Added harmonic filter in blue box below for 2.3/2.5/2.6 TTA modules:

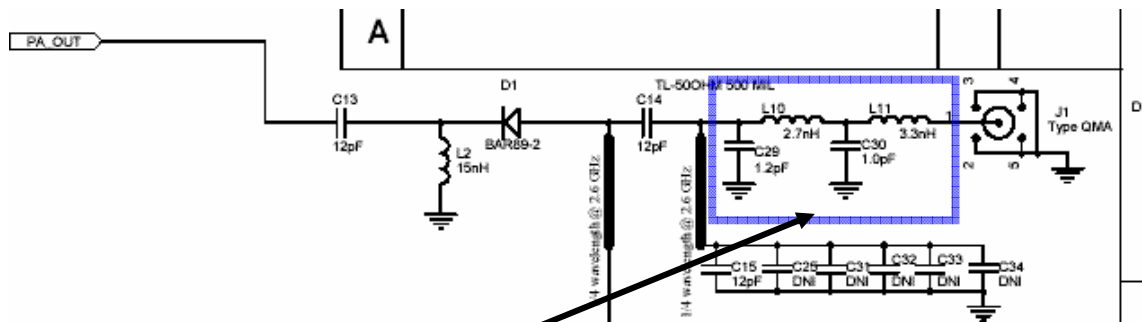
L10= 2.7nH, 08-00220-00R
C29 = 1.2pF, 02-00207-00R
C30=1pF, 02-00206-00R
L11 = 3.3nH, 08-00163-00R

Also SUBBED in a Peak Devices part: 29-00046-00R for 2.3 TTA module
29-00045-00R for 2.5 and 2.6 TTA module

Filter changed on 2.3 TTA module to frequency range 2300 to 2400 MHz....filter widened 5 MHz....old filter was 2305 to 2400 MHz...08-00209-01R is the new filter.

Filter changed on 2.5 TTA module to frequency range 2496 to 2620 MHz...filter widened 20 MHz on top end and 4 MHz on lower end...old filter was 2500 to 2600 MHz...08-02558-00R is the new filter.

Filter changed on 2.6 TTA module to frequency range 2595 to 2690 MHz...filter widened 4 MHz on top end...old filter was 2596 to 2686 MHz...08-02643-00R is the new filter.
